NOTICE UNDER SCHEDULE VI CHAPTER XI, RULE 2 (I) OF
THE CITY OF KARACHI MUNICIPAL ACT 1933.

KARACHI MUNICIPAL CORPORATION
BUILDING SECTION.

REVIEW FORM.

PROPOSED BUILDING ON PLOT NO 30 SHEET NO M.M.2

PLAN OF FIRST & SECOND FLOOR.

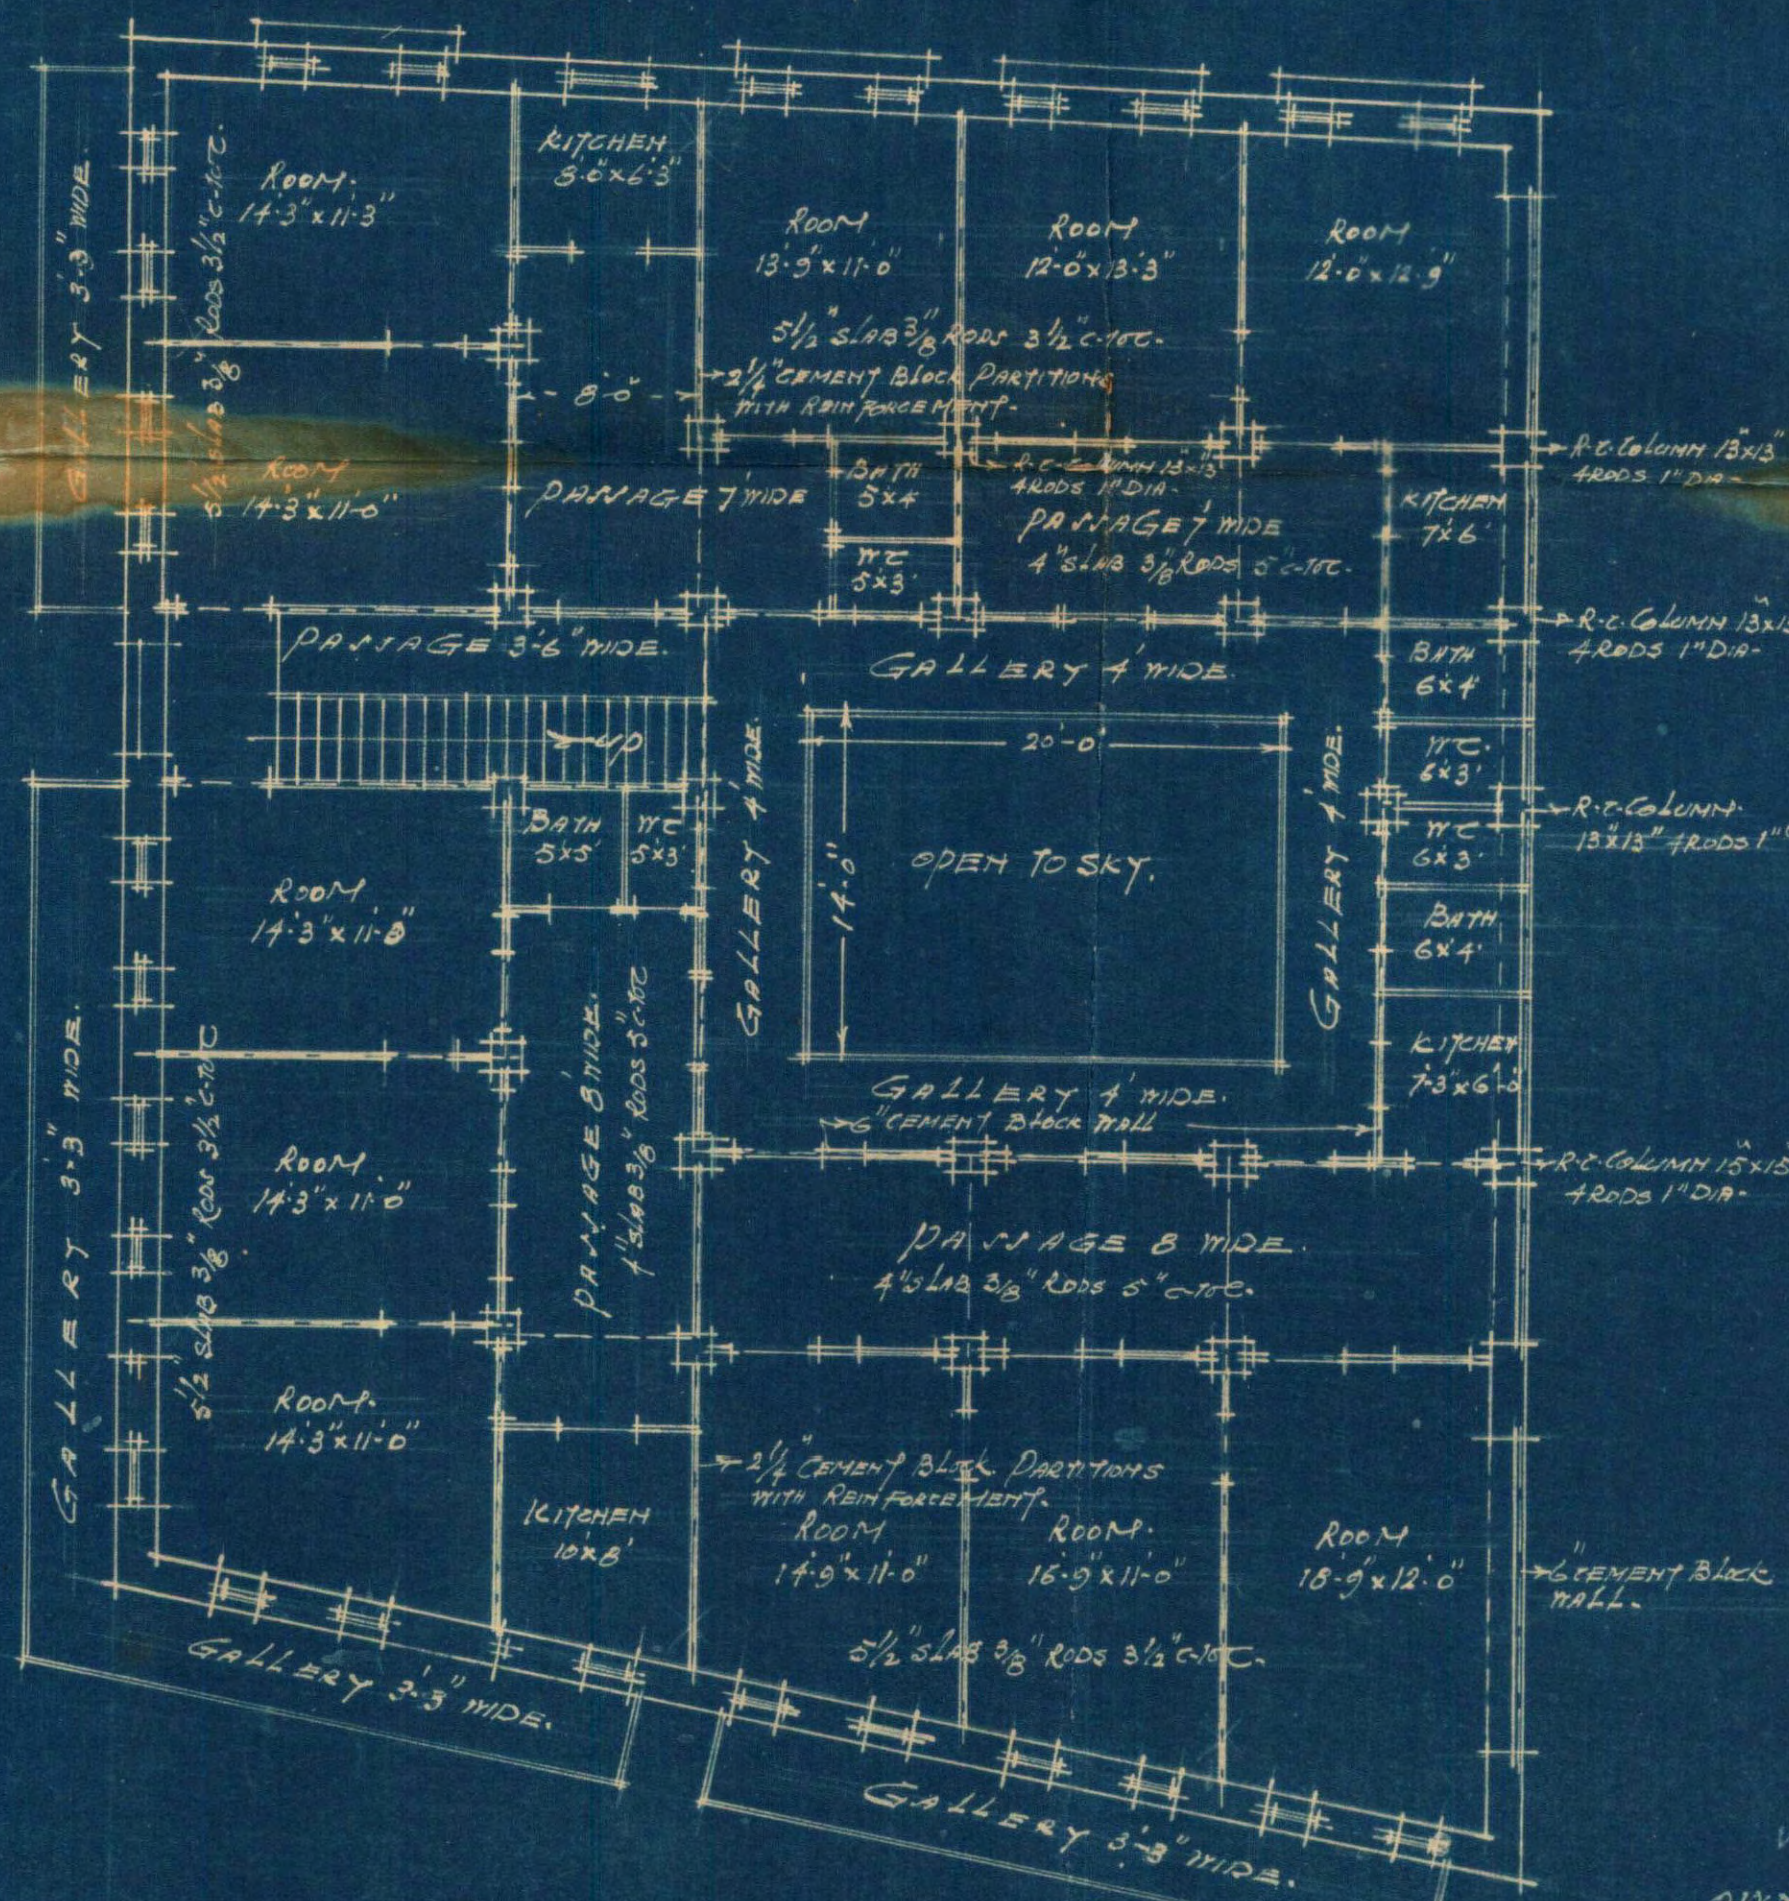
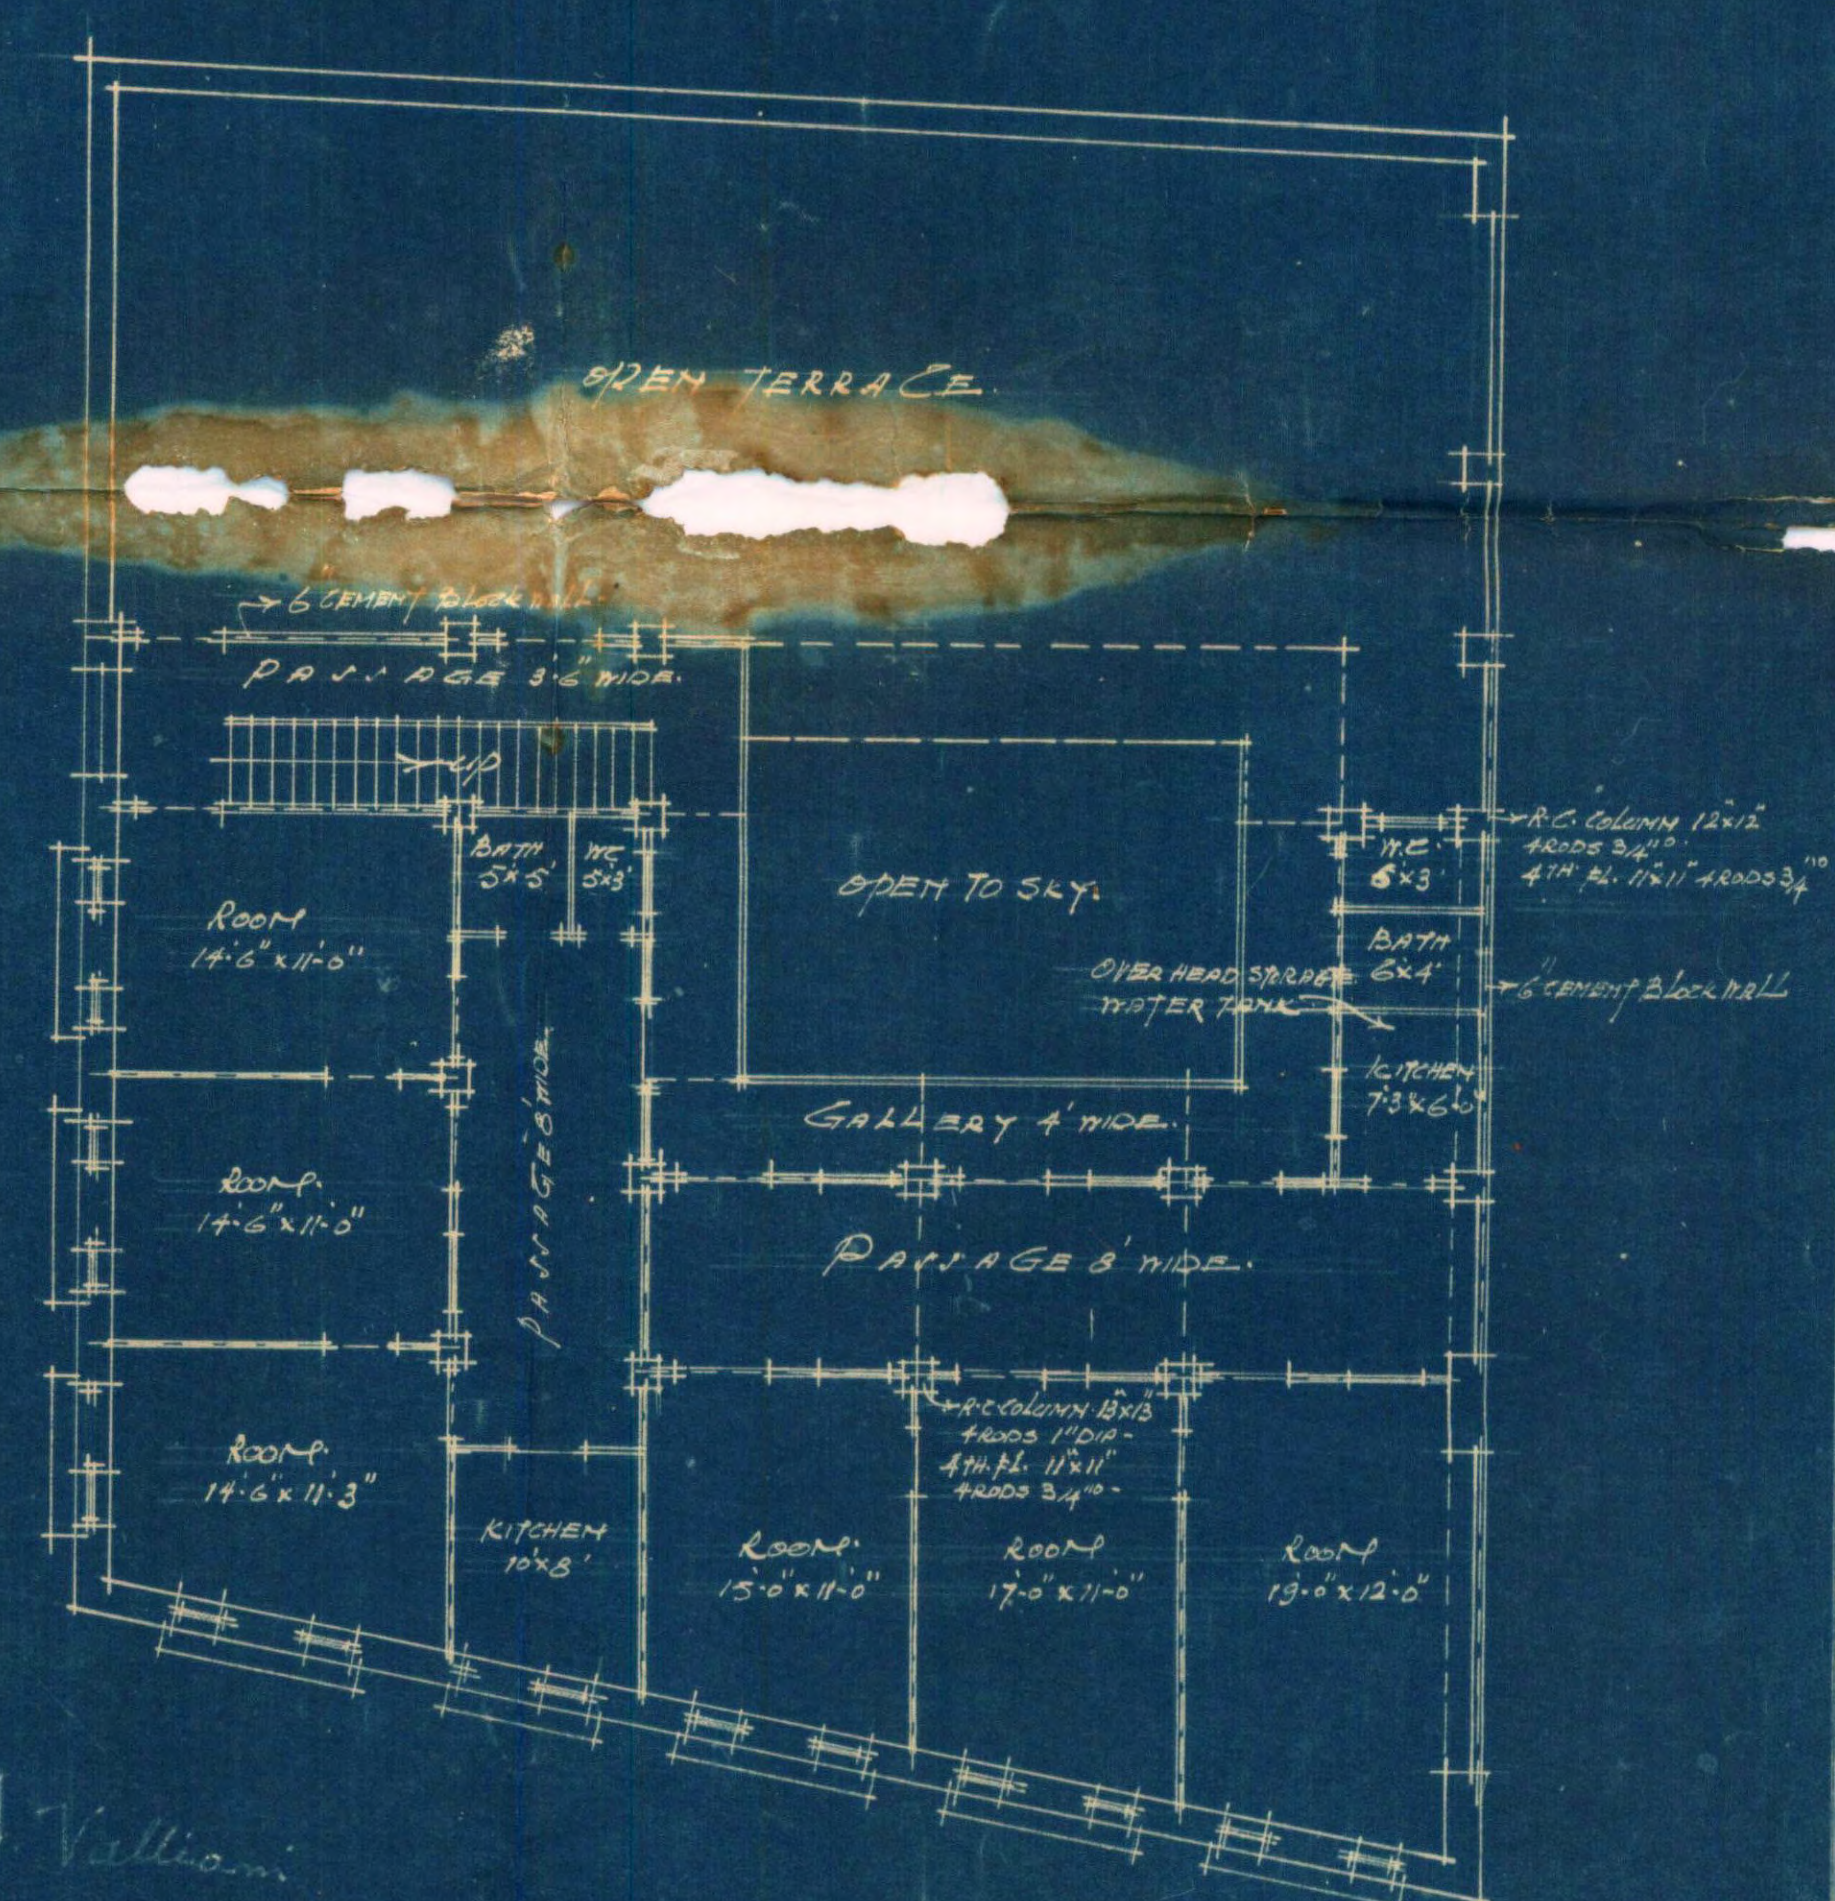
Underground water tank should be
sufficiently away from the drainage line.

The area of plot is not shown on the plan.

- (2) 1. Thickness of walls on the 1st floor must be $23\frac{1}{2}$ " in accordance with the Bombay Byelaws.
- (3) 2. The height of the building be regulated in accordance with by-law 233(4) of this Corporation.
- (4) 3. Continuous galleries are shown as proposed as here were continuous galleries before. Orders are requested whether these be restricted to 15' length and also whether weather shade be allowed on account of the existence of the old roof as shown in the attached photograph.
4. The balconies must be at the same height as the old balconies.
- (5) 5. The parapet wall on Esra Street be proposed balustraded.

1. Underground water tank should be sufficiently away
from the drainage line.
2. The thickness of walls on the first floor must be $23\frac{1}{2}$ ".
3. The height of the building be regulated in accordance
with bye law 233(4) of this Corporation.
4. Galleries be proposed at the same height at which they
were existing as before and they be limited to 15'-0
long & only.
5. The parapet wall on Essa street be proposed balustrated.

With reference to your office No.BSP 626/36
dated 17th instant and as personally arranged with your
goodself, we beg to return herewith the plans complying
with your objections Nos.1, 2, 4 & 5 and shall thank you
to kindly return us the same duly approved.

There is no objection as per connected
position of the tank.
